AGENDA
CHARTER TOWNSHIP OF MERIDIAN
ENVIRONMENTAL COMMISSION
JOINT COMMISSION MEETING AND
REGULAR MEETING
July 10, 2019 7:00 pm

3. APPROVAL OF THE AGENDA
4. APPROVAL OF THE MINUTES
5. PUBLIC REMARKS
6. NEW BUSINESS
 - a. Wetland Permit Application: Central Meridian Trail Connector
7. OLD BUSINESS
8. CHAIR'S REPORT
9. STAFF REPORT
10. COMMISSION/LIASON/WORKGROUP REPORTS
 - A. Planning
 - B. Land Preservation
 - C. Energy
 - D. Brownfield Redevelopment Authority
 - E. Green Team
 - F. Transportation
11. PUBLIC REMARKS
12. ADJOURNMENT

PROJECT	CENTRAL MERIDIAN REGIONAL TRAIL CONNECTOR MERIDIAN TOWNSHIP INGHAM COUNTY, MICHIGAN
APPROVED	DBH
CHECKED	DBH
DRAWN	HTR
JOB NO.	18-0066
DATE	4/18/2019
SCALE	AS NOTED
SHEET NO.	C2.0

PROJECT: DBH
 CHECKED: DBH
 DRAWN: HTK
 JOB NO.: 18-0066
 DATE: 3/18/19
 SCALE: AS NOTED
 SHEET NO.: C7.0

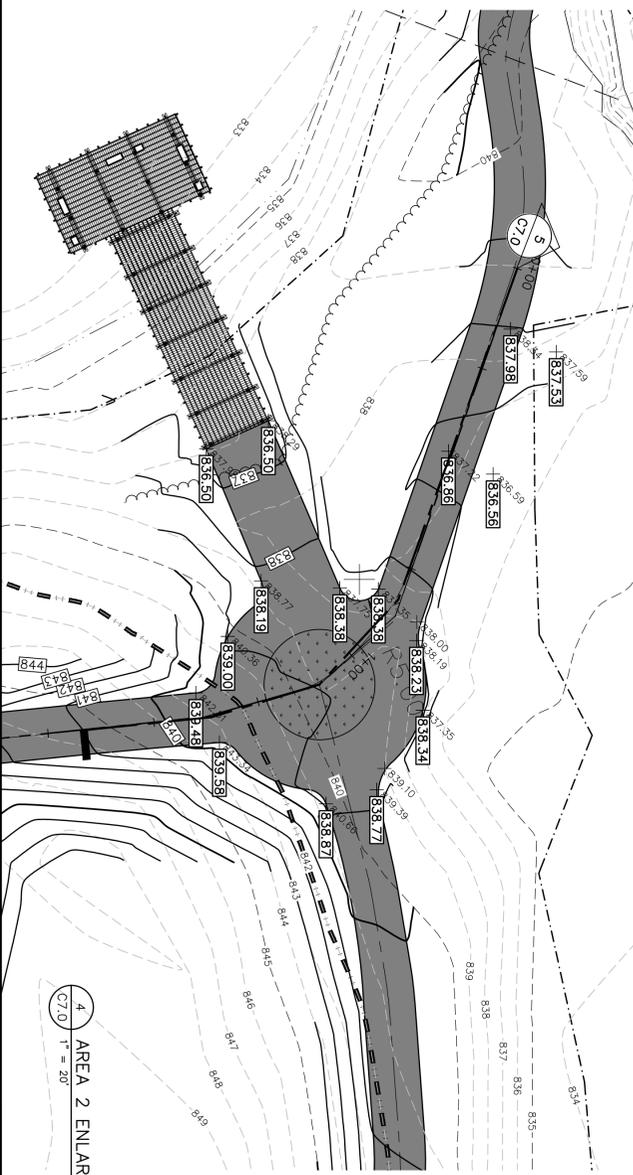
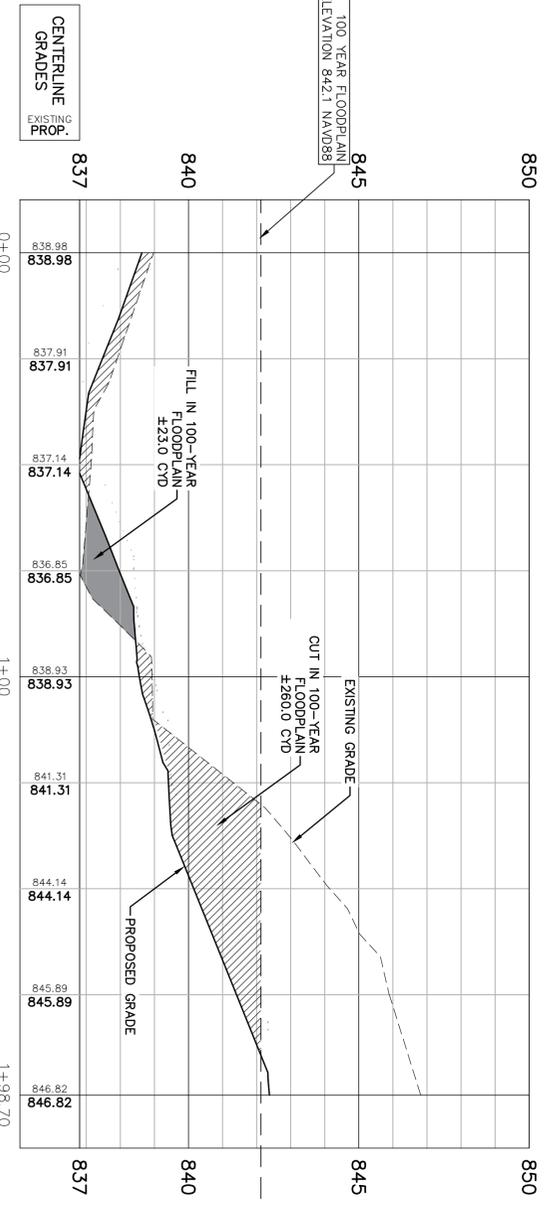
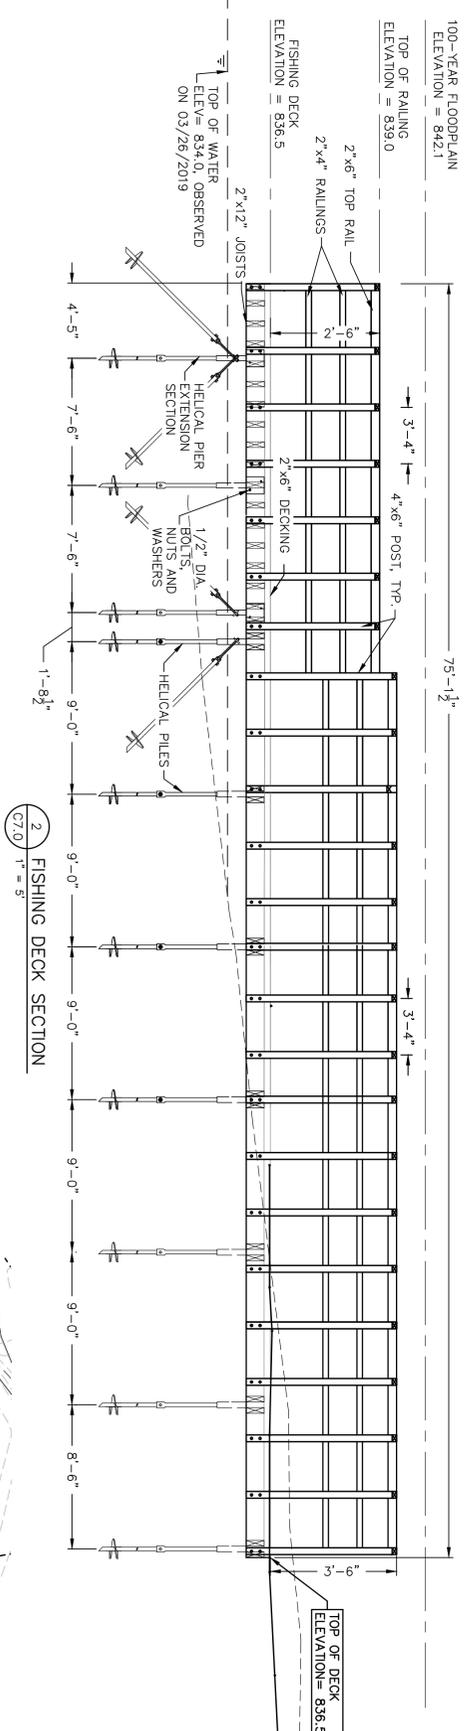
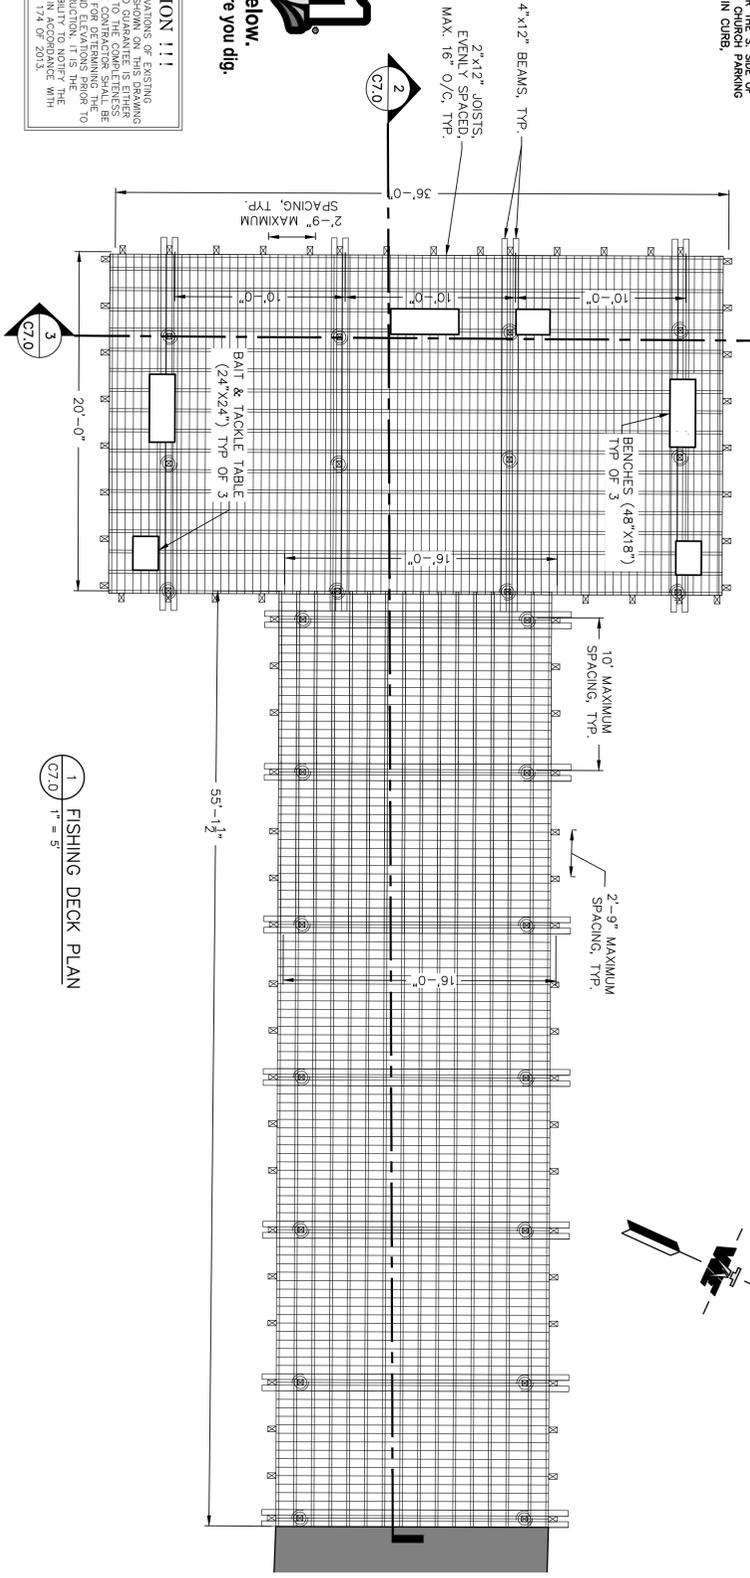
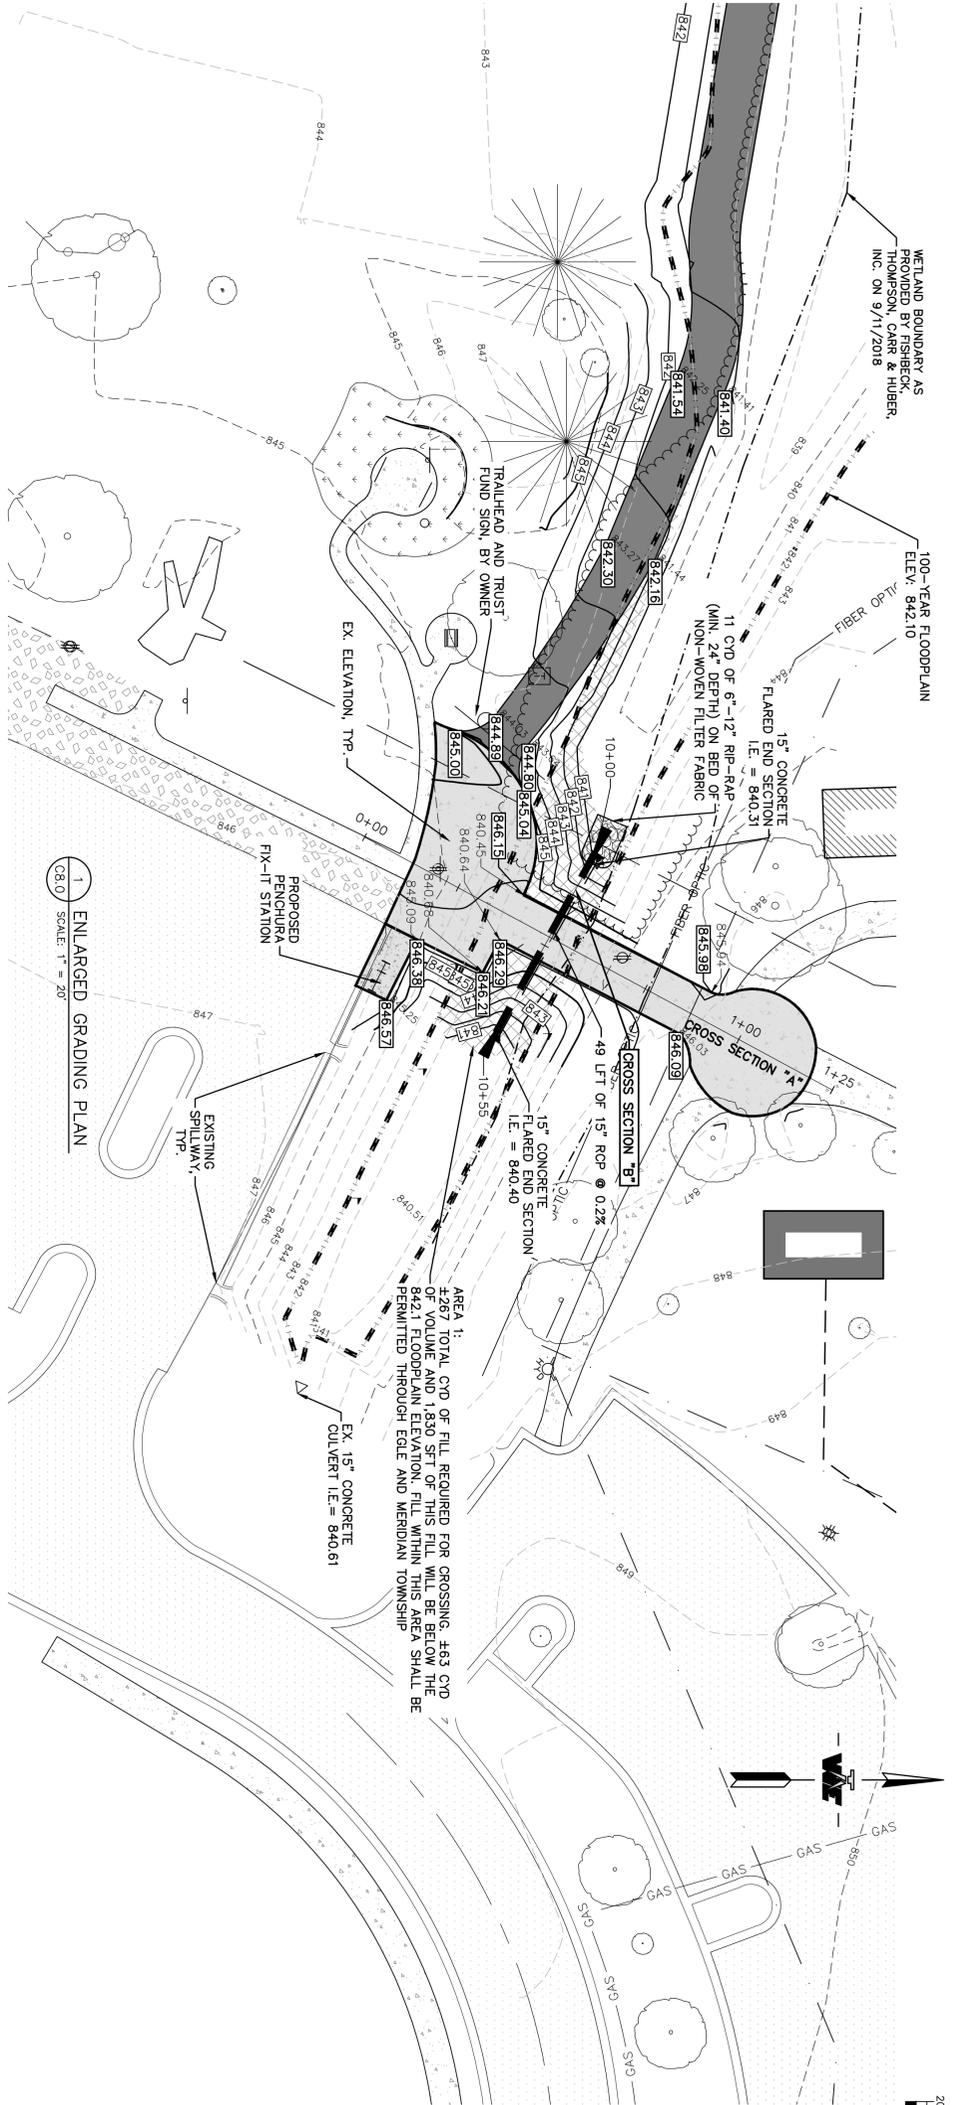
Please clarify the volume of fill or excavation related to the boardwalk and fishing deck. Specifically list the volume of excavation associated with installing pilings or leveling the existing grade to prepare to install the pilings of the boardwalk and fishing pier. Also identify the disposal location of spoils (non-wetland, non-flood plain, and on township owned property). Part 2: Sheet C8.0 shows 180 feet of 15" RCP and a new bioswale over the 15" pipeline. This appears to be work in wetland and a replacement of existing pipe. This work is not listed in the application but shown on plans and does not appear to be associated with or included in the trail head path work. Provide wetland impact details of area and volume for the pipe replacement.

Table has been removed from plans as it related to cut and fill for the entire project and not just work within floodplain/wetland areas. Please see "Correction request statement" and notes/cross-sections shown on sheets C7.0 & C8.0 for additional cut/fill information.

LOCATION	WETLAND REMOVAL (SFT)	CUT VOLUME (CVD)	FILL VOLUME (CVD)
AREA 1	-1890	0	63
AREA 2	0	-260	23
FISHING DECK*	0	0	14.9
BOARDWALK*	0	0	47.6
WETLAND MITIGATION	4,100	-130	0
WETLAND TOTAL	2,210	-390	148.5
ADDED WETLAND AREA		2,210	-241.5
